**AMENDMENT – 3**

RFP No: **CANW-1/IWAI/JMV/16**

**Assignment Title: Engineering Procurement and construction contract for New Navigational Lock at Farakka, West Bengal**

This amendment forms an integral part of the Bid Document issued on 27<sup>th</sup> May, 2016.

JOB. NO. **I-525** DRG. NO. **FL-004**

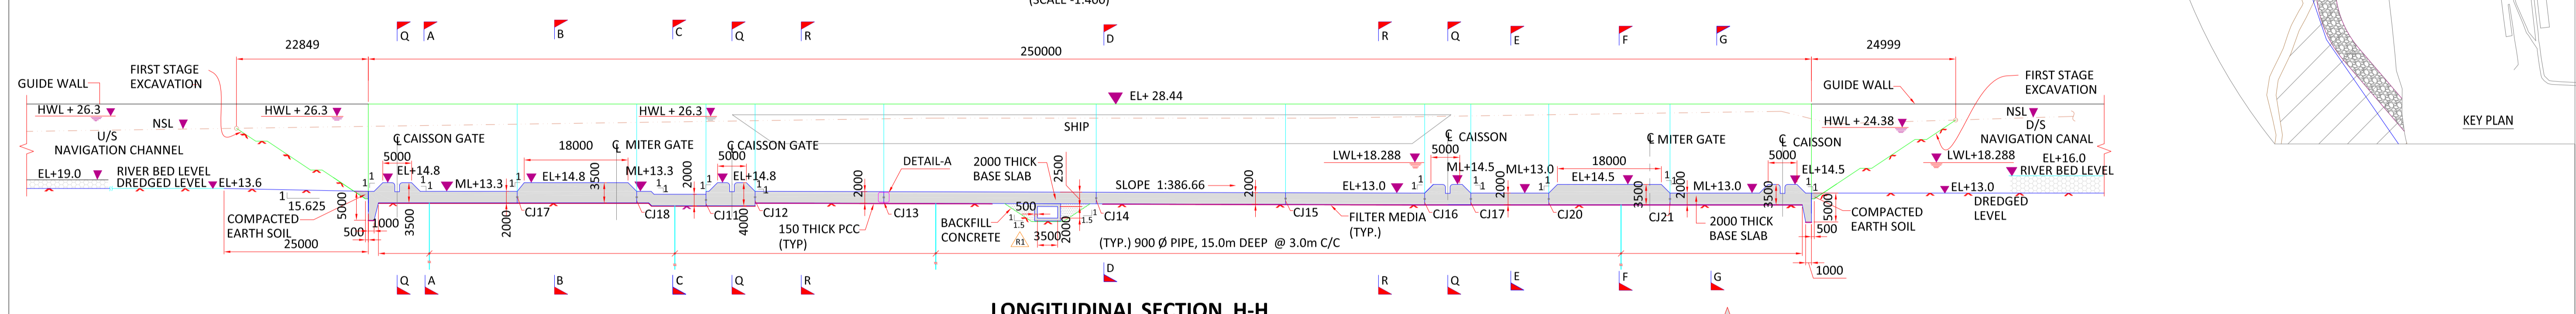
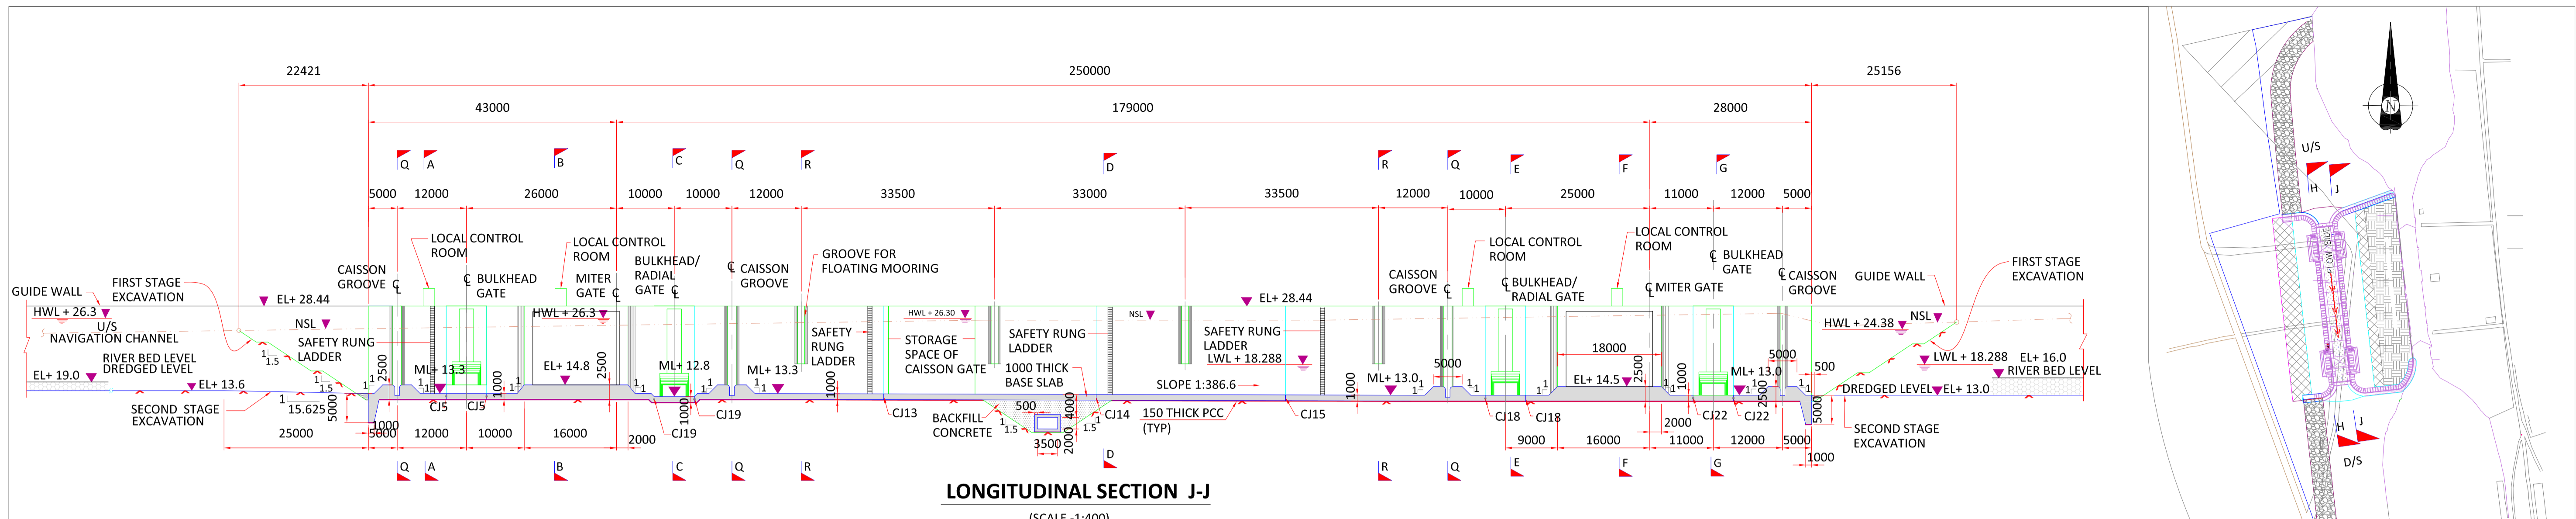
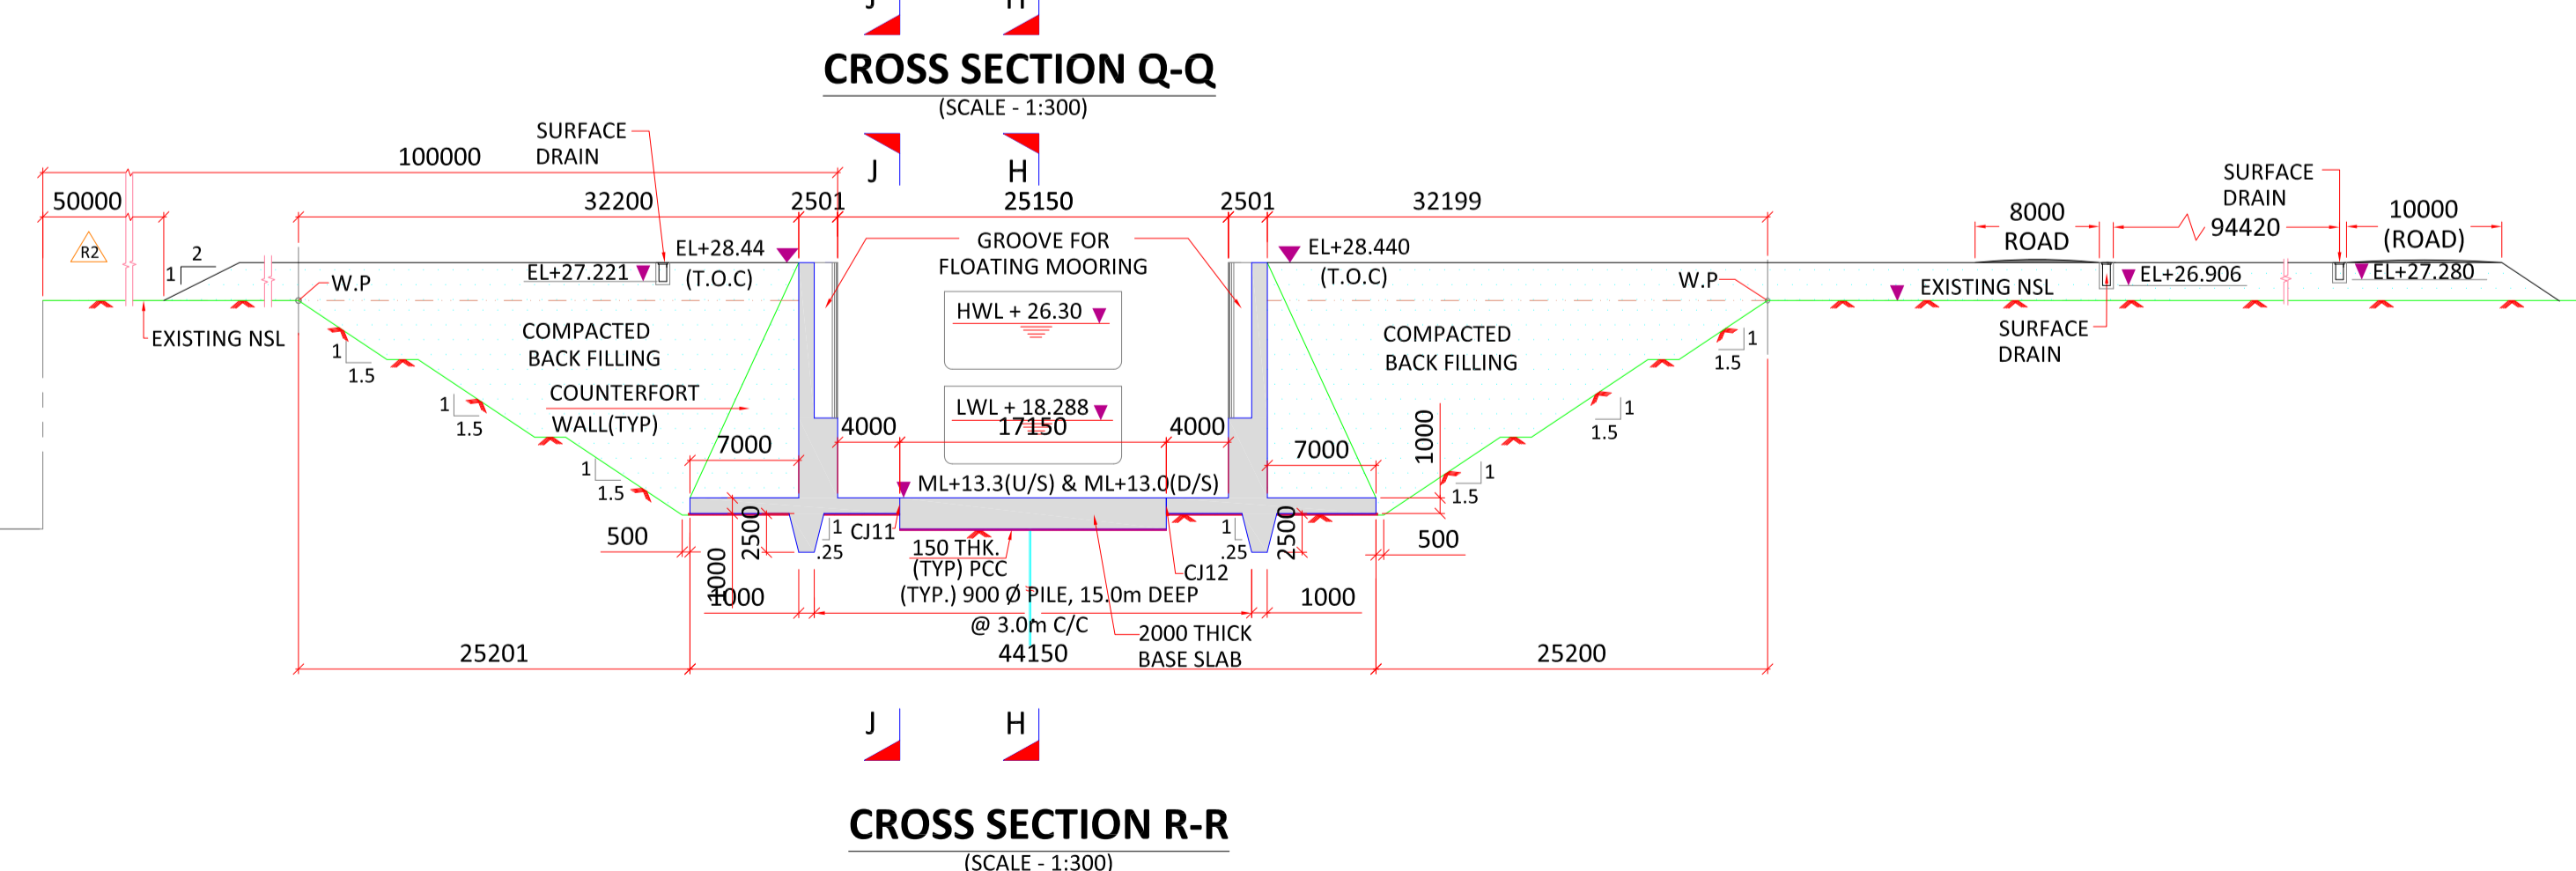
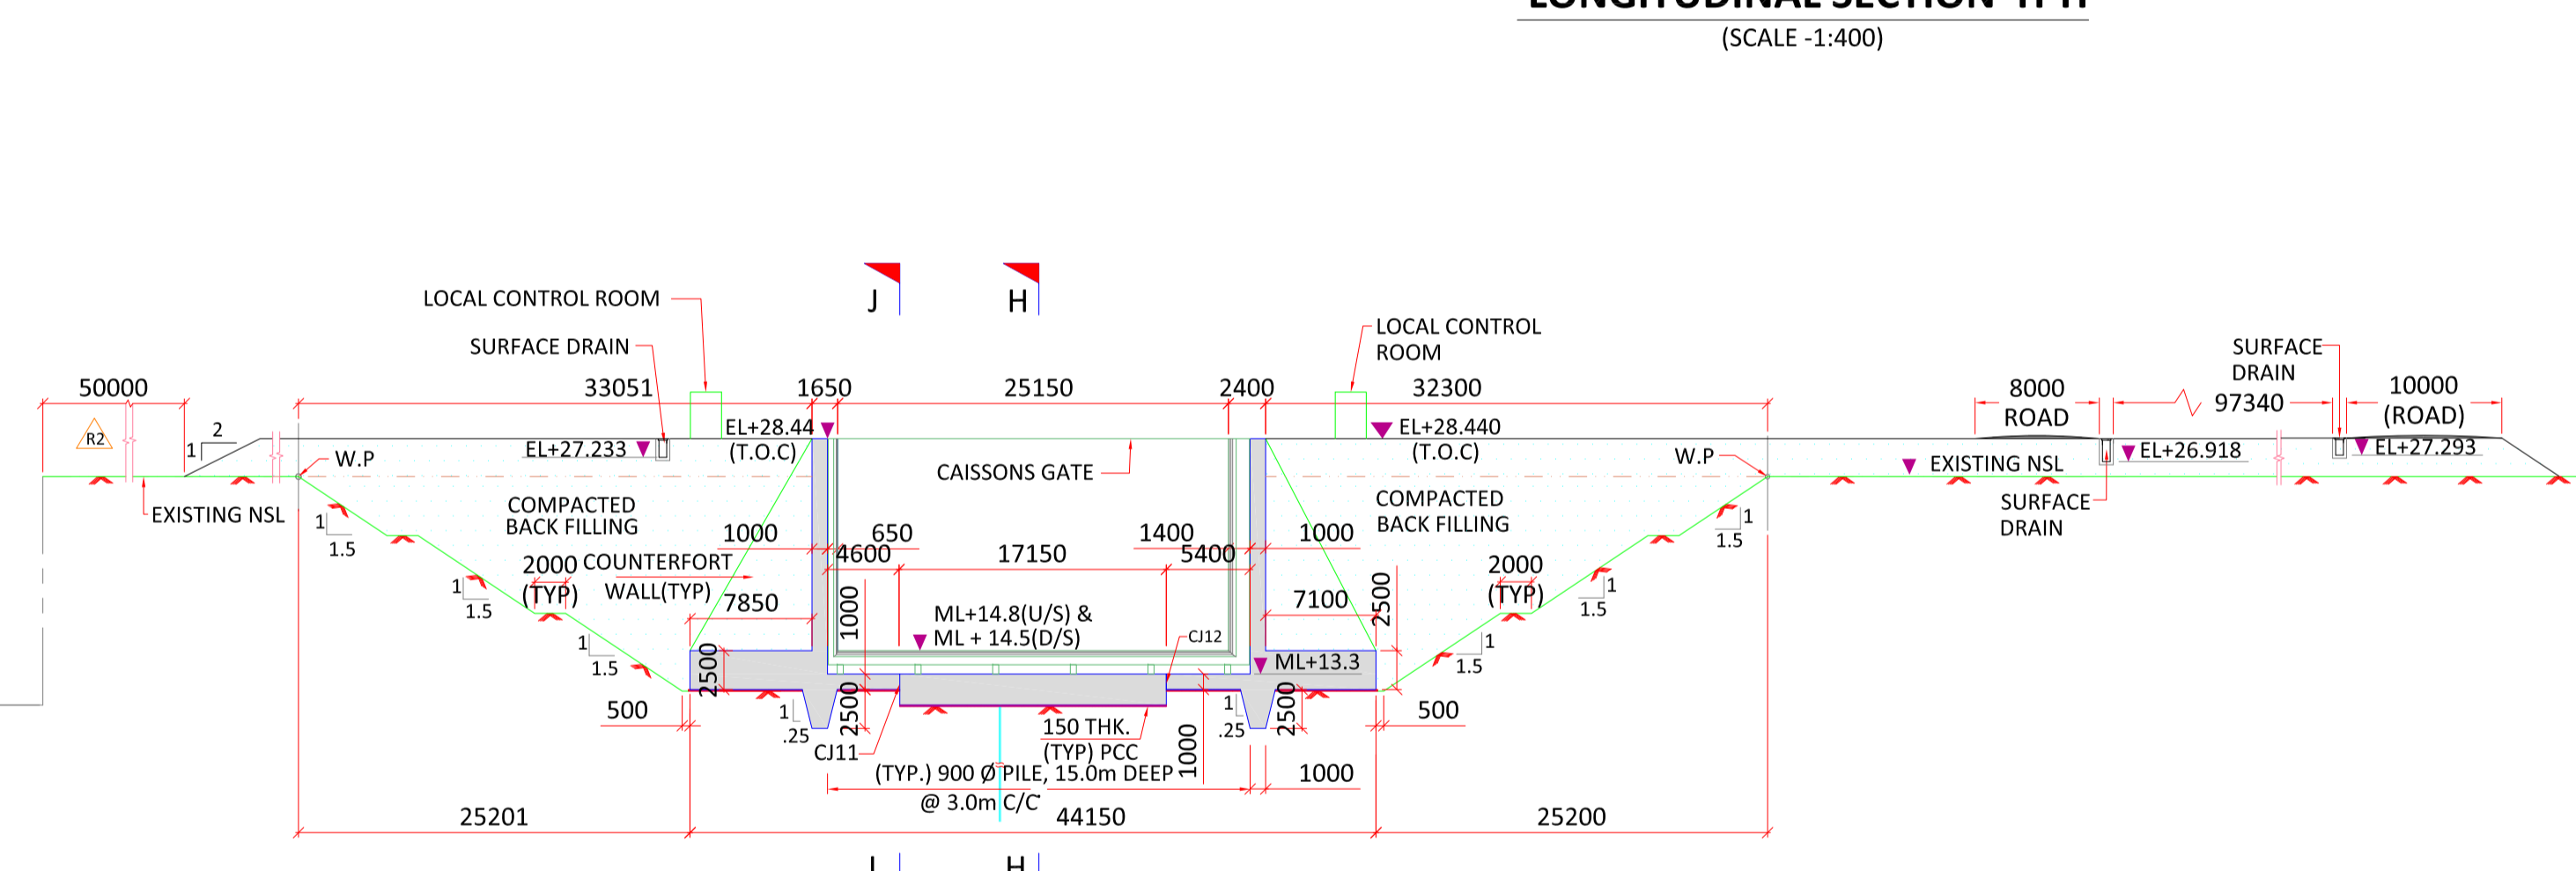
<b>S. No</b>	<b>Vol., Section &amp; Clause No. in Bid Document</b>	<b>Original Text</b>	<b>Replace with</b>
			venue as mutually agreed (for foreign bidder)
12.	Volume-2	FI-004	Revised drawing is enclosed
13.	Volume-2	FI-005	Revised drawings are enclosed (SH 1 and 2)
14.	Volume-2	FI-014	Revised drawing is enclosed
15.	Volume-2	FI-015	Revised drawing is enclosed

REV	DATE	DESCRIPTION	DRN	CHD	APD
R2	27.07.16	MODIFICATION IN FORMATION LEVELS	KS	SKA	SD
R1	12.07.16	MINOR MODIFICATION	KS	SKA	SD
